Docket No. 50-259

Change No. 2  
License No. DPR-33

CHANGE NO. 2 TO THE TECHNICAL SPECIFICATIONS  
(APPENDIX A)  
TENNESSEE VALLEY AUTHORITY  
DOCKET NO. 50-259

Figure 3.5.1 Maximum Allowable Planar LHGR

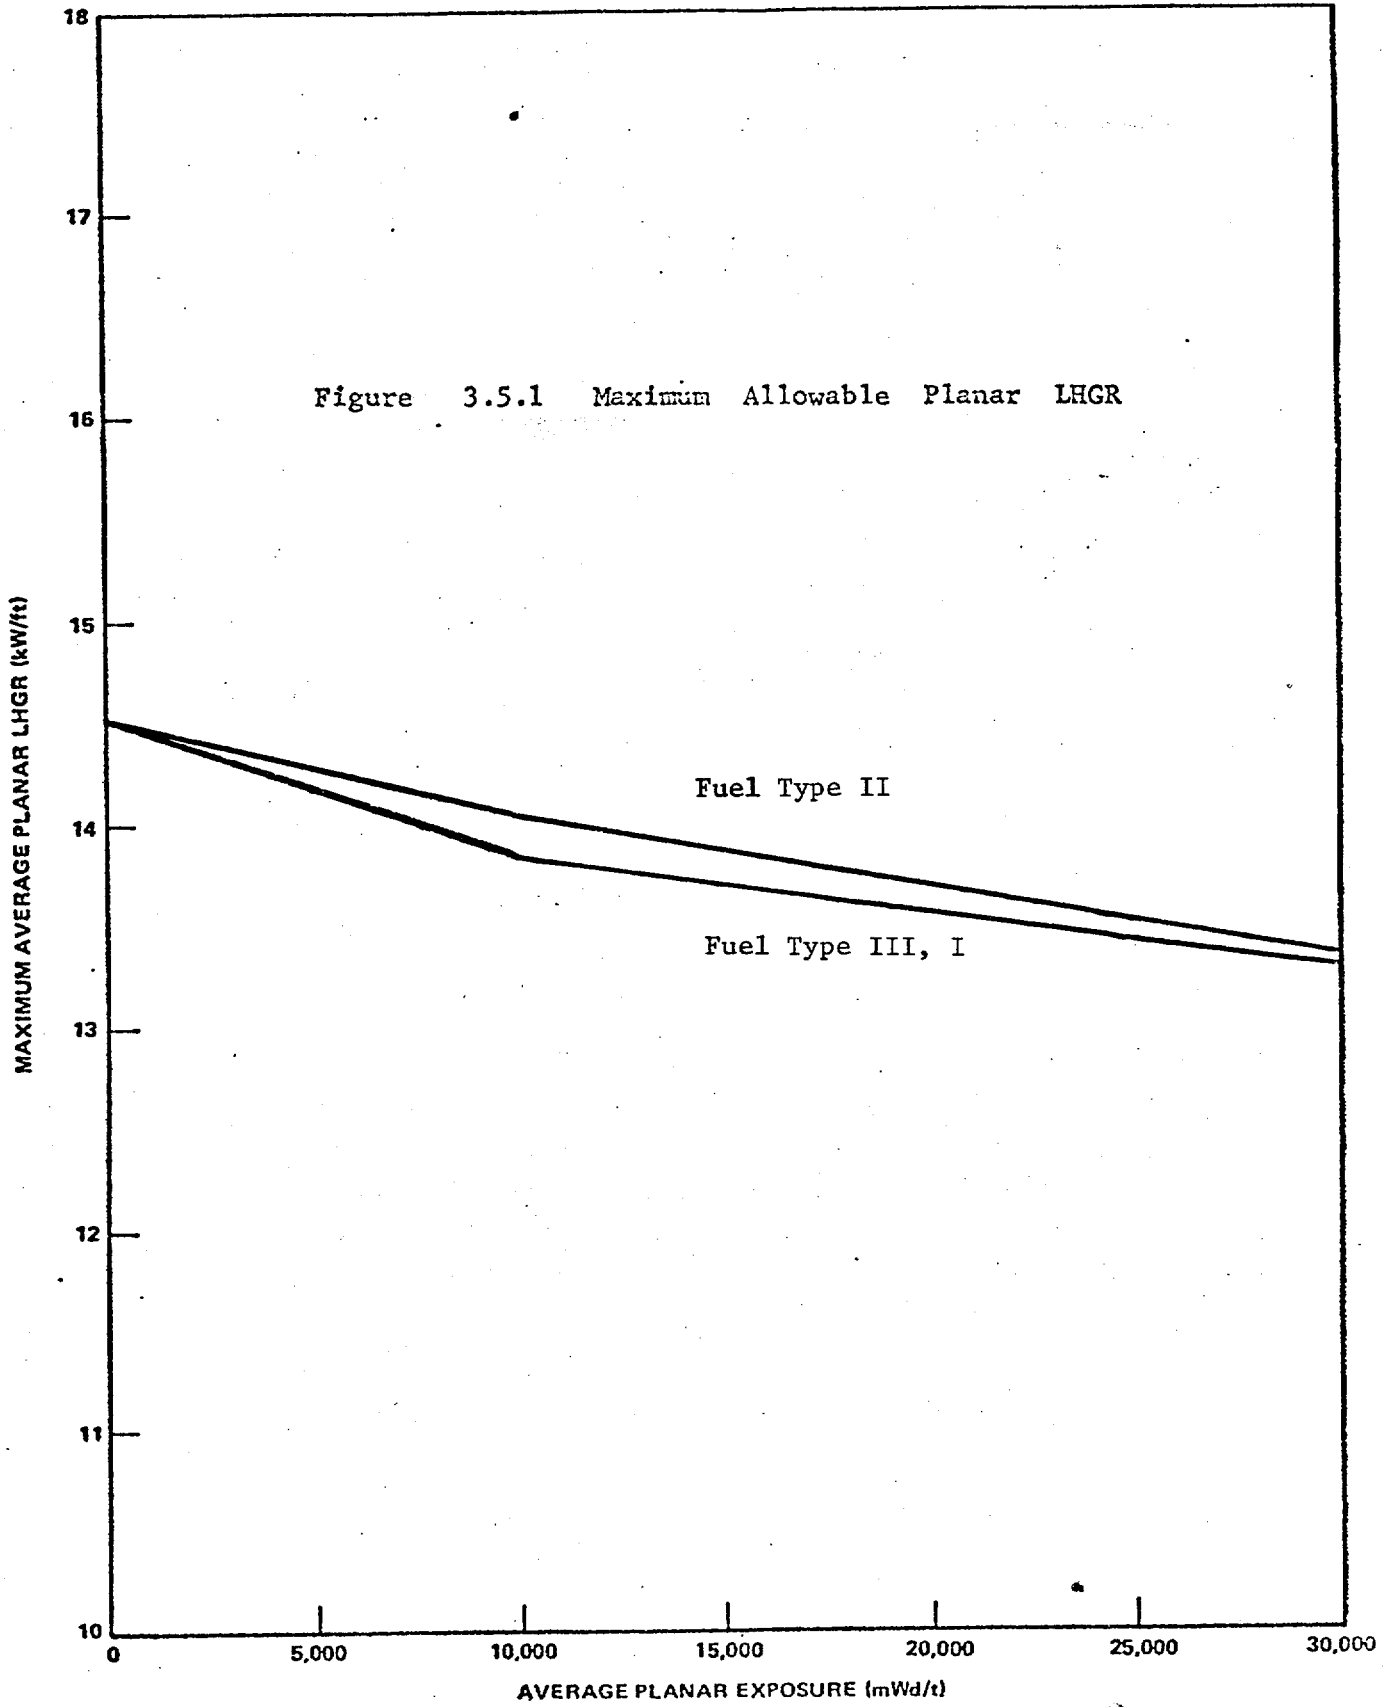
During steady state power operation, the average linear heat generation rate (LHGR) of all the rods in any fuel assembly, as a function of average planar exposure, at any axial location, shall not exceed the maximum average LHGR shown in Figure 3.5.1.

The maximum average planar LHGR shown in Figure 3.5.1 is the same as that shown on the curve labeled " $\gamma$ " (gamma) on Figures 1 & 2 forwarded by letter of October 25, 1973 from GE (I. Stuart) to AEC (V. Moore) replacing Figures 4-9F1 and 4-9F2 of GE topical "Fuel Densification Effects on General Electric Boiling Water Reactor Fuel," NEDM-10735, Supplement 6, August 1973 and is the result of the calculations presented in Section 4.3.4 of the same report. These calculations were made to determine the effect of densification on peak clad temperature and were performed in accordance with the AEC Fuel Densification Model for BWR's which is attached to NEDM-10735, Supplement 6 as
